ADDENDUM NO.2

Re: **GS# 104-184**
Fant Library Renov. – PH III (Buildout)
Mississippi University for Women
(Institutions of Higher Learning)
Columbus, Mississippi

PROJECT: GS# 104-178
FANT LIBRARY RENOV – PH 3
BUILD OUT
MISSISSIPPI UNIVERSITY FOR WOMEN
COLUMBUS, MISSISSIPPI

(PARTIAL Plan View) Display Case TYPE 2 @ Archives 215 13/9.1
1/2"

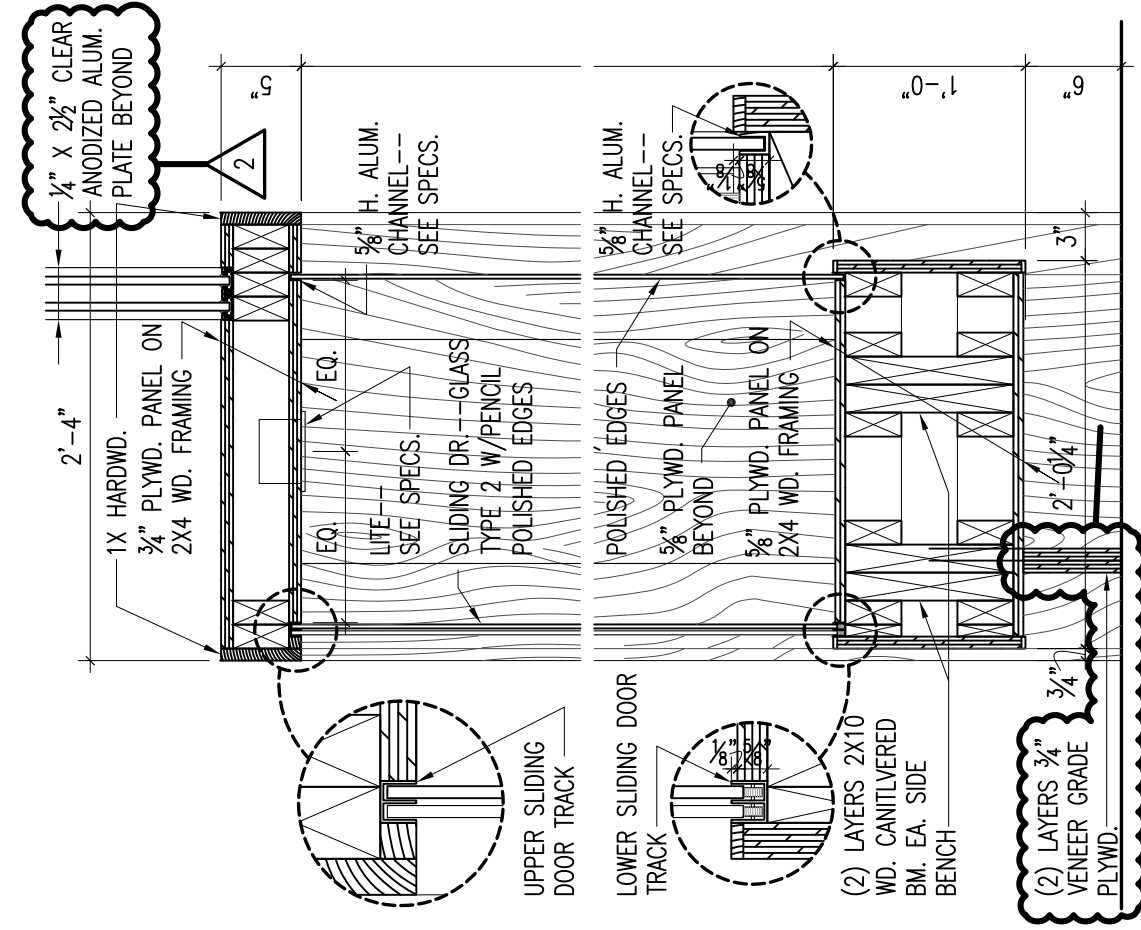
- Item No. 12:** Refer to Sheet 9.1, and change details "13" and "18" as shown at attached Exhibit "I".
- Item No. 13:** Refer to Sheet 9.4, Detail "4", and replace Sign "Type H" with Exhibit K, attached hereto.

M1.4R1

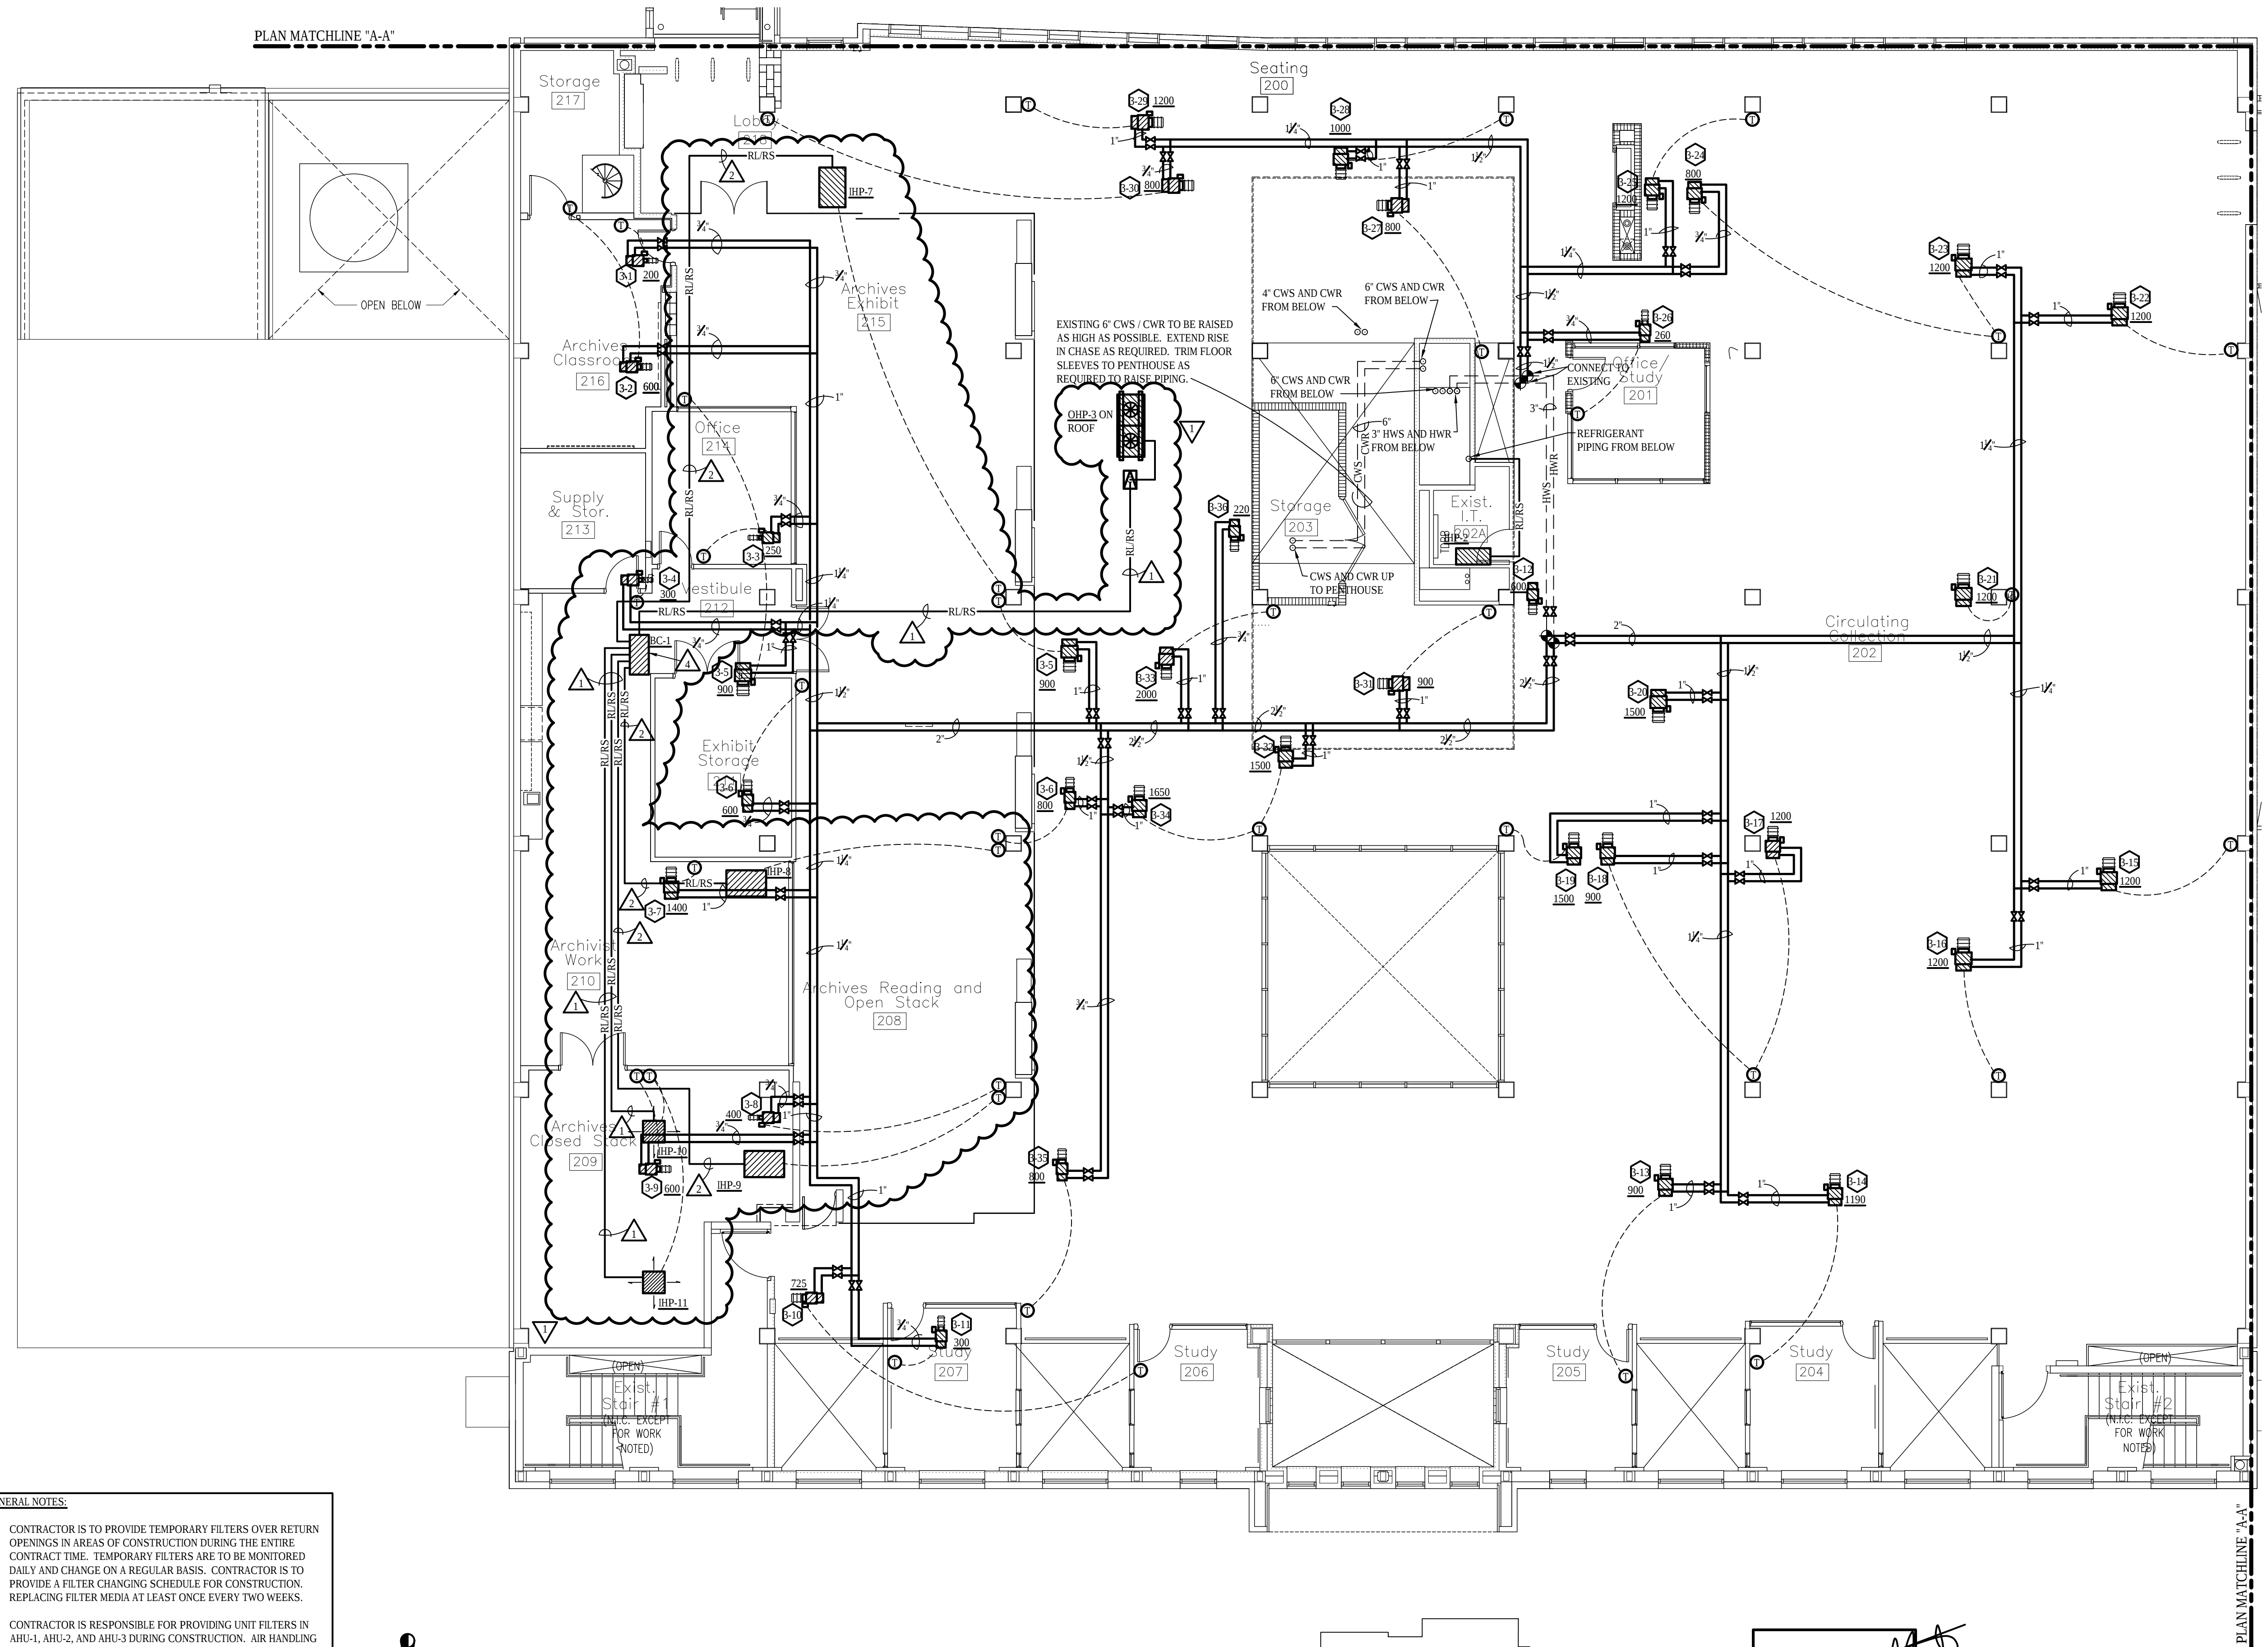
- Item No. 6: Drawings, Sheet M1.4: Add IHP-3 through IHP-6 for redundancy in ASRS Vault as shown on attached Drawing M1.4R1
- Item No. 7: Drawings, Sheet M2.2: Add OHP-3, BC-1, and IHP-7 through IHP-11 for redundancy in the Archives Reading and Storage Areas. Add refrigerant piping and thermostats for related heat recovery system added for redundancy as shown on attached Drawing M2.2R1.

P1.2R1

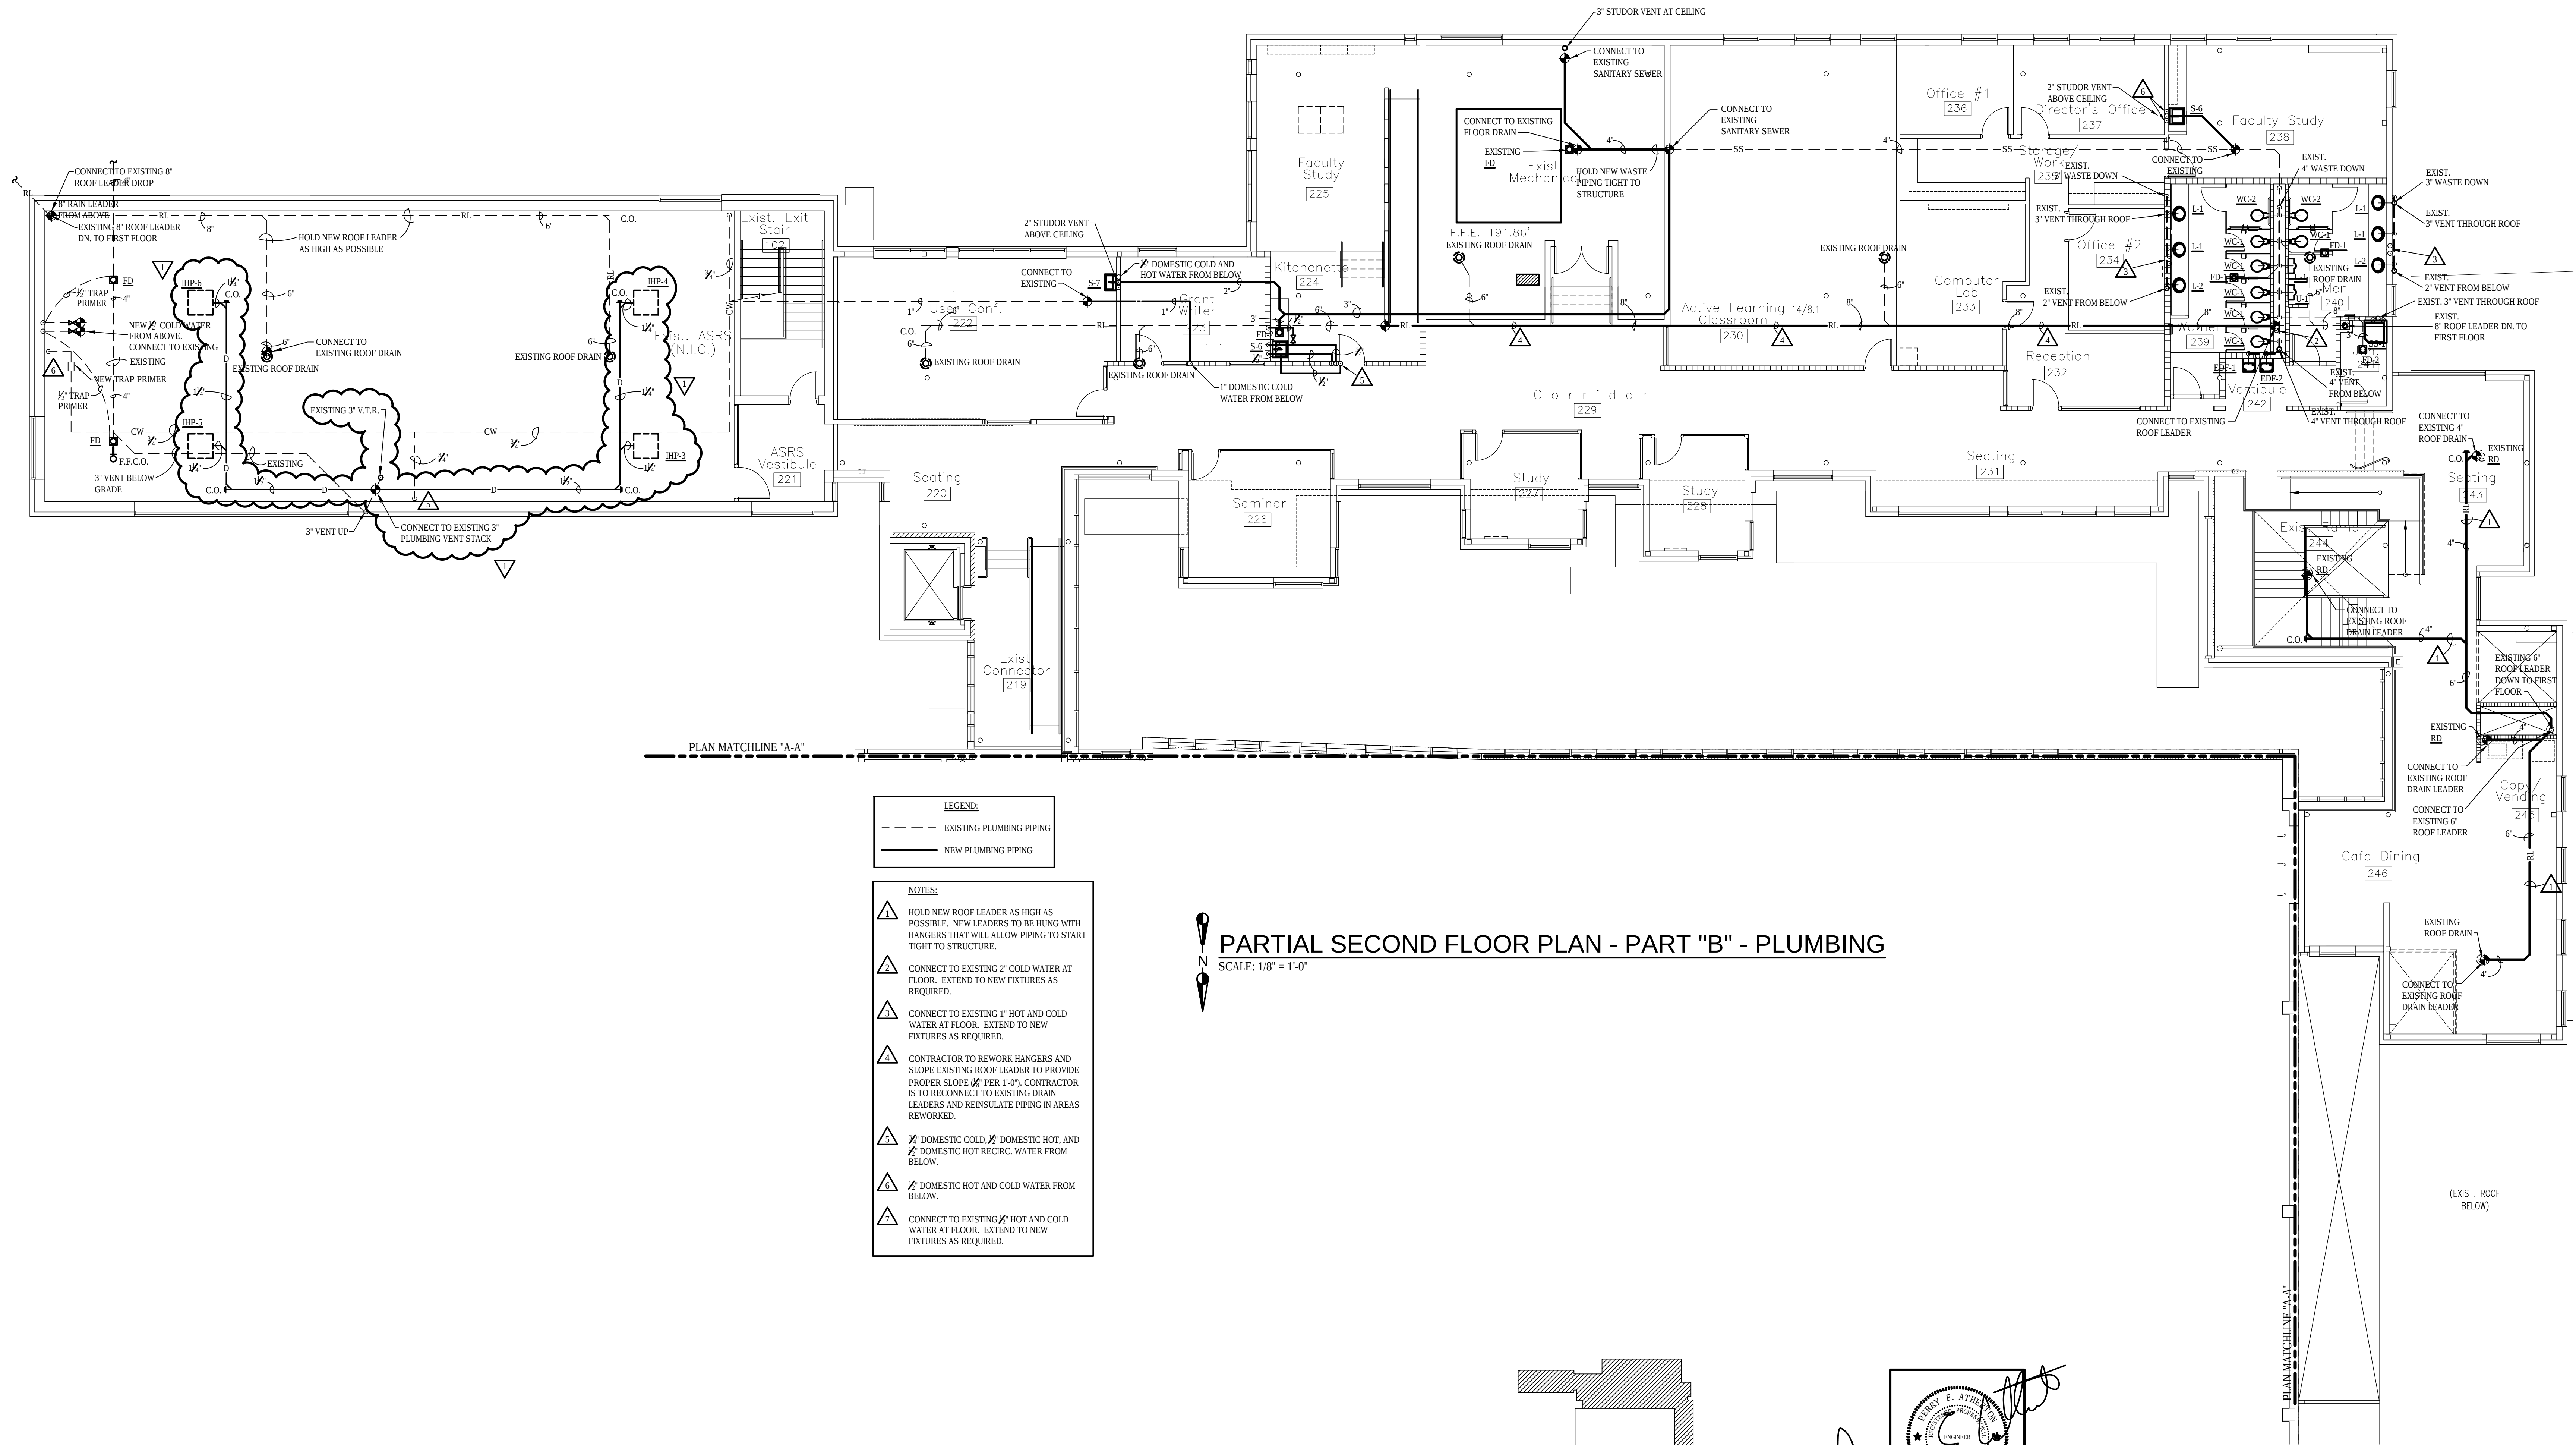
- Item No. 11: Drawings, Sheet P1.2: Add condensate drain piping for BC-1 and IHP-7 through IHP-11 as shown on attached Drawing P1.2R1.
- Item No. 12: Drawings, Sheet P1.3: Add condensate drain piping for IHP-3 through IHP-6 as shown on attached Drawing P1.3R1.

AE-4

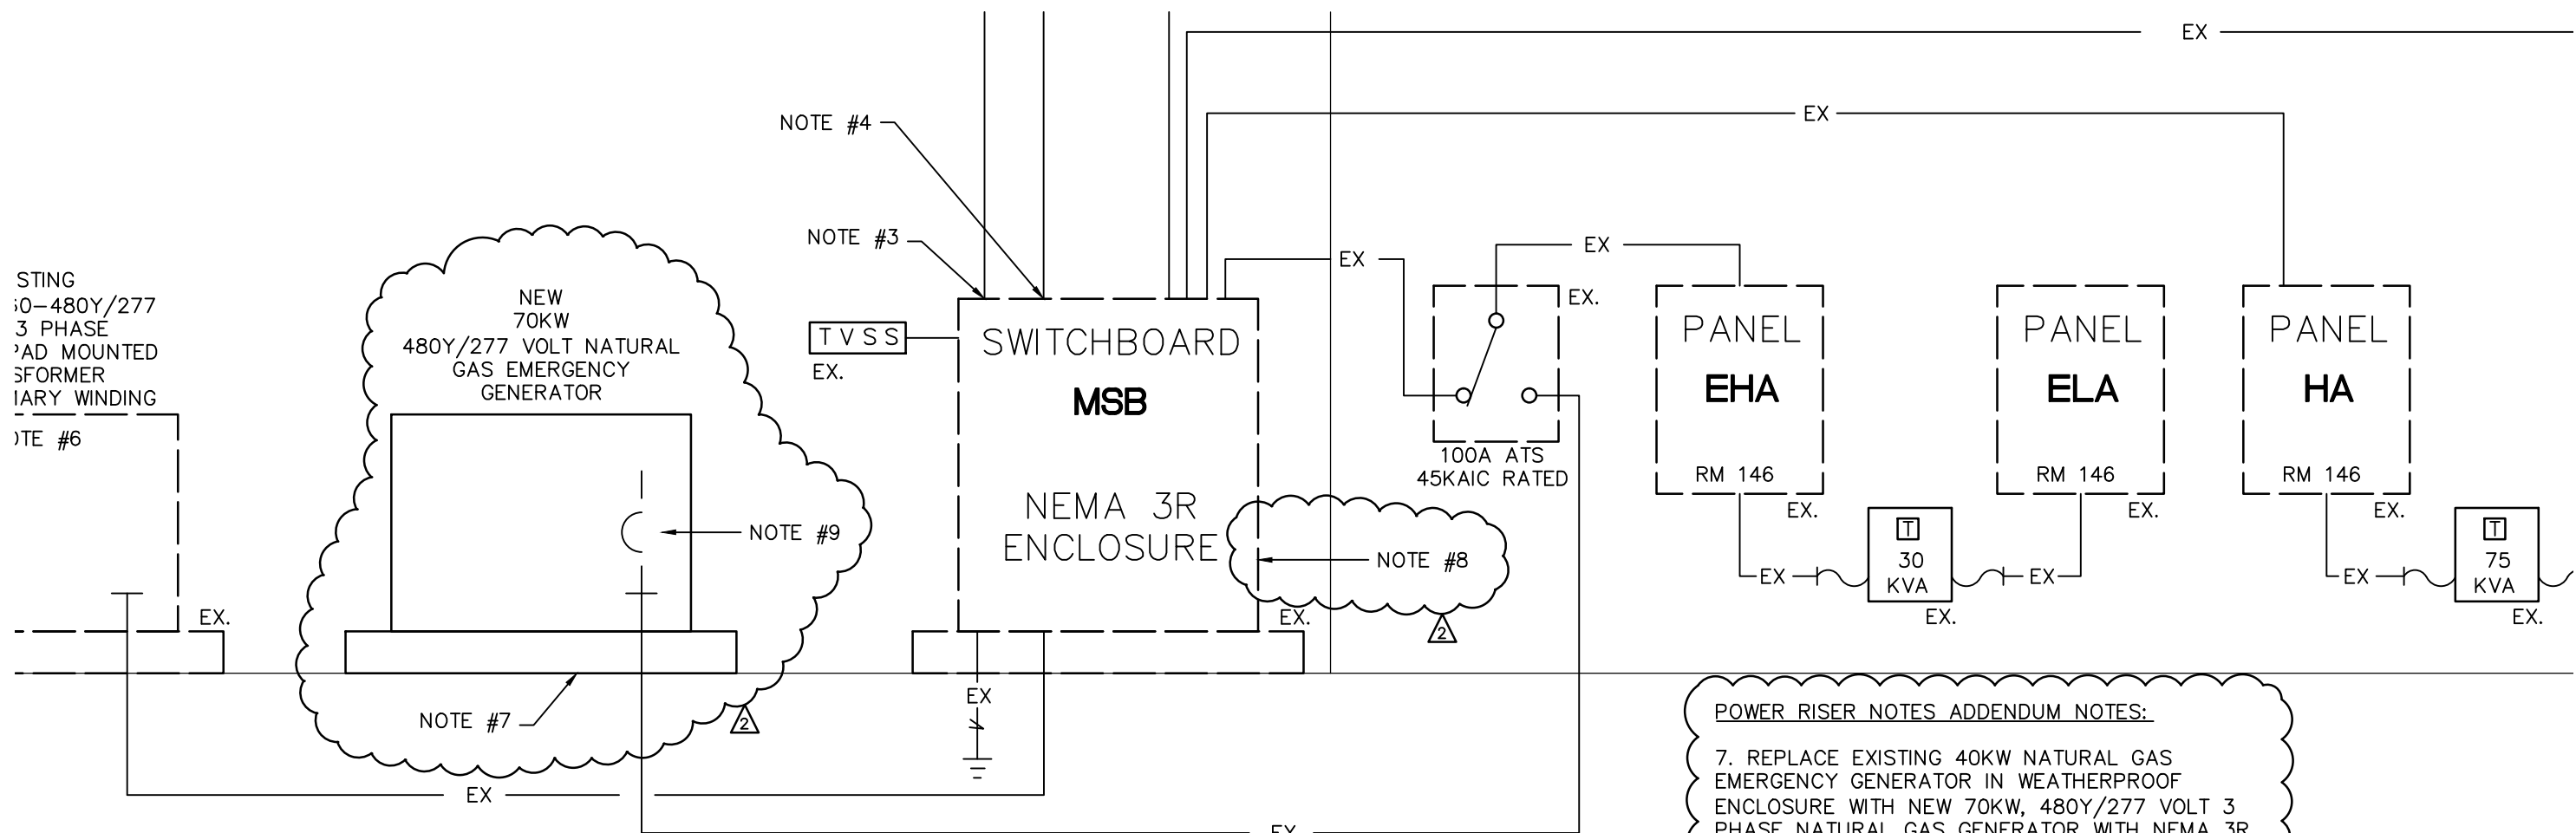
7. REPLACE EXISTING 40KW NATURAL GAS EMERGENCY GENERATOR IN WEATHERPROOF ENCLOSURE WITH NEW 70KW, 480Y/277 VOLT 3 PHASE NATURAL GAS GENERATOR WITH NEMA 3R WEATHERPROOF ENCLOSURE. REWORK EXISTING ELECTRICAL AND NATURAL GAS CONNECTIONS TO BE RECONNECTED TO NEW UNIT AS REQUIRED. ADJUST CONCRETE PAD AS NEEDED.

8. CHANGE EXISTING 60A3P BREAKER IN MSB FOR PANEL "EHA" THROUGH THE ATS TO BE A 100A3P BREAKER AND RECONNECT EXISTING #2 FEEDER CONDUCTORS.
